CITY PLAN COMMISSION

FILE NUMBER: S245-067

LOCATION: Hawes Avenue at Maple Avenue, southeast corner

REQUEST: An application replat a 3.407-acre tract of land containing all of Lots 3 and 5 and a tract of land in City Block 2570, and to include abandoned portion of right-of-way to create one lot on property located Hawes Avenue at Maple Avenue, southeast corner.

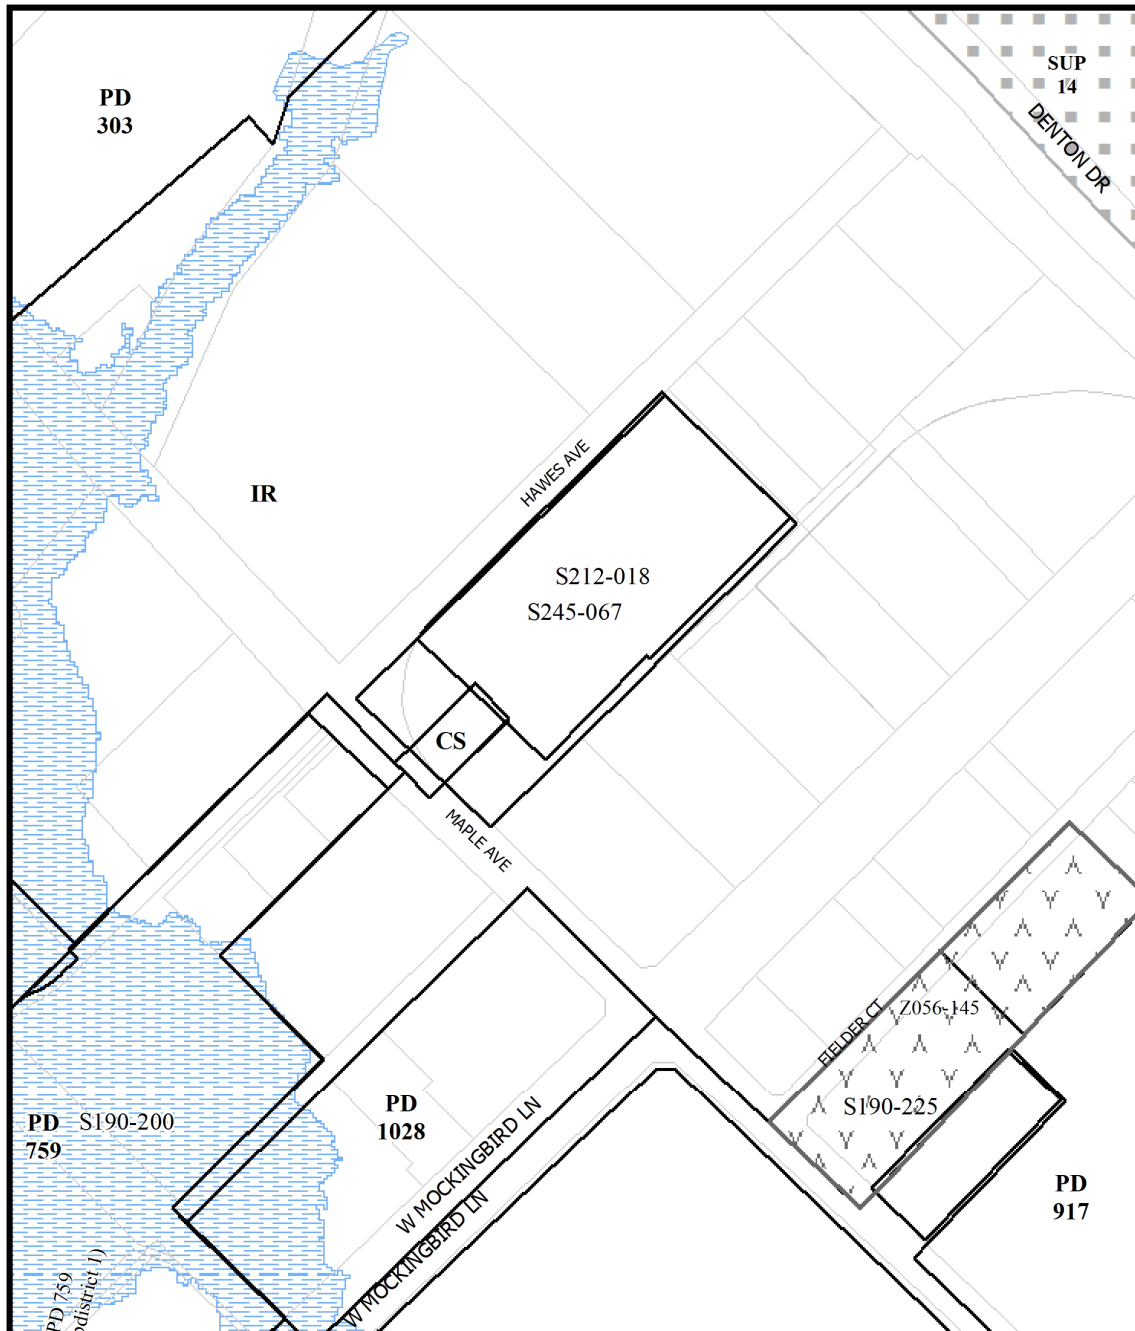
15. On the final plat, dedicate a minimum 5-foot by 5-foot corner clip (via fee simple or street easement) at the intersection of Hawes Avenue & Maple Avenue. Section 51A 8.602(d)(1)

16. A larger corner clip may be requested during engineering plan and traffic review to accommodate an adequate turning radius, or to maintain public/traffic appurtenances, within the area of the corner clip. *Section 51A 8.602(d)(1), 51A 8.608(a)*
17. Must coordinate with Transportation Department for any traffic signal requirements that are deemed necessary for improving pedestrian accessibility and safety related to site development (Contact Srinivasa Veeramallu with Traffic Signals). *51A-8.606, 51A-8.608*

20. On the final plat, show how all adjoining right-of-way was created. *Section 51A-8.403(a)(1)(A)(xxii)*.
21. On the final plat, show distances/width across all adjoining right-of-way. *Platting Guidelines*.

22. On the final plat, show recording information on all existing easements within 150 feet of the property.
23. On the final plat, list utility easements as retained within street abandonments when stated in the abandonment ordinance or follow the City of Dallas standard affidavit requirements.

24. On the final plat, show all additions or tracts of land within 150 feet of the property with recording information. *Platting Guidelines*.
25. On the final plat, show or list the prior plat on the map, in the legal description, and/or title block. *Platting Guidelines*.

26. On the final plat, chose a new or different addition name.

27. Additional design information is required for assessment. Site plan must be submitted showing proposed development, building finished floor elevation, development, existing mains – including downstream manhole, and proposed water and wastewater service locations. Submit water/wastewater engineering plans to 320 E. Jefferson Blvd., Room 200, Attention: Water and Wastewater Engineering.

28. Prior to the final plat, please note Hawes Street right-of-way abandonment on the plat at follows: Abandonment authorized by Ordinance No._____, recorded as Inst. Nos. (Cert. ORD No._____, QCD No._____). Utility Easements retained.
29. On the final plat, change “Maple Ave” to “Maple Avenue”. *Section 51A-8.403(a)(1)(A)(xii)*.

30. On the final plat, change “Hawes Ave” to “Hawes Avenue”. Section 51A-8.403(a)(1)(A)(xii).
31. On the final plat, identify the property as Lots 3A in City Block 2570.
